Model Error Resolution Document

1. Originator: Jerry McNeish	2. Date: April 16, 2008	3. ERD No. MDL-WIS-PA-000005 ERD 02
---------------------------------	----------------------------	--

4. Document Identifier: MDL-WIS-PA-000005 REV 00; and AD 01	5. Document Title: Total System Performance Assessment Model/Analysis for the License Application
--	---

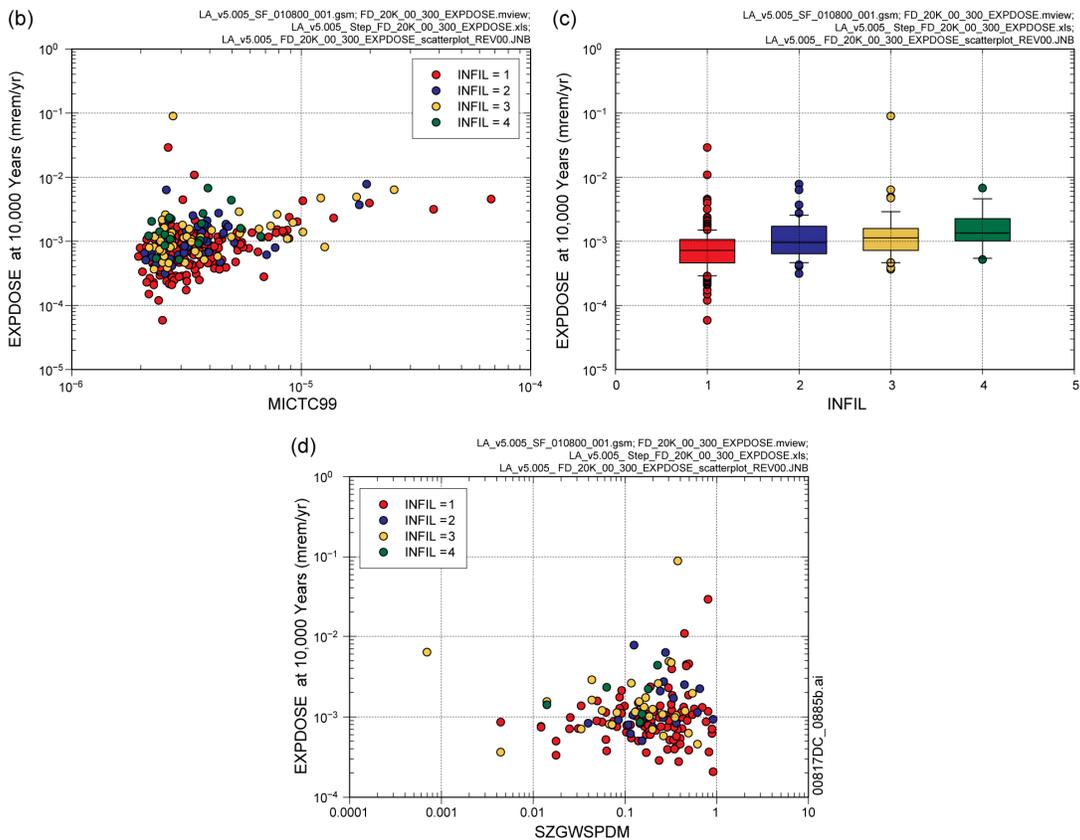
CR 11885—Incorrect information in Appendix K. The three scatterplots at the bottom of Figure K7.8.2-2[a] (00817DC_0882a) are repeats of the scatterplots in Figure K7.8.1-2[a] (00817DC_0885a) rather than the intended scatterplots. The figure needs to be updated with the correct scatterplots. The corrected figure (K7.8.2-2[a]) is provided in Attachment 2 to this ERD. Figure K7.8.1-2[a] is also included in Attachment 2 to correct a minor formatting error on the y-axis of scatterplot (b).

Figure 8.3-7c[a]. Fraction of Drift Filled with Rubble

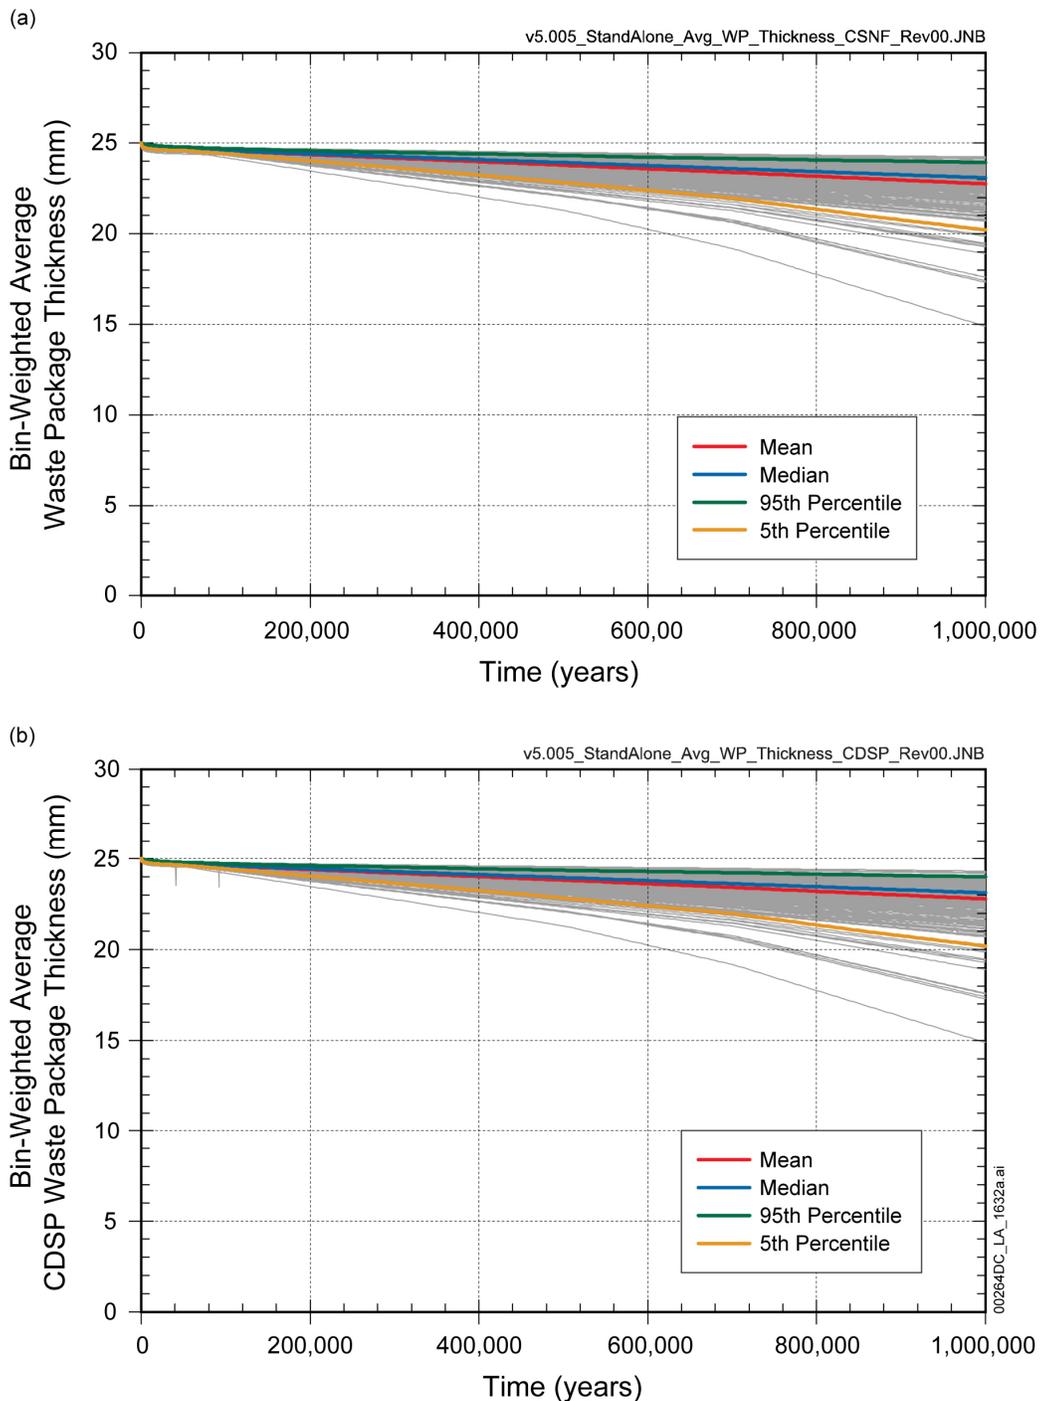
CR 11909—Supplemental Plots. AMR MDL-WIS-PA-000005, Rev. 00, TSPA-LA and Addendum 01 did not provide plots for data found in DTN: MO0801TSPA WPDS.000 and MO0710ADTSPA WO.000 related to the "Fraction of Drift Filled with Rubble", and the "Spatially Averaged Waste Package Outer Barrier Thicknesses for 1 Million Years for (a) Commercial SNF Waste Packages and (b) Codisposal Waste Packages." A new output DTN (MO0803TSPA SAR.000 [DIRS 185276])

provides the plots generated from the two noted DTNs. This issue is known by the authors of the SAR and the appropriate corrective actions are being incorporated during the development of the SAR. See Attachment 5 for the new figures.
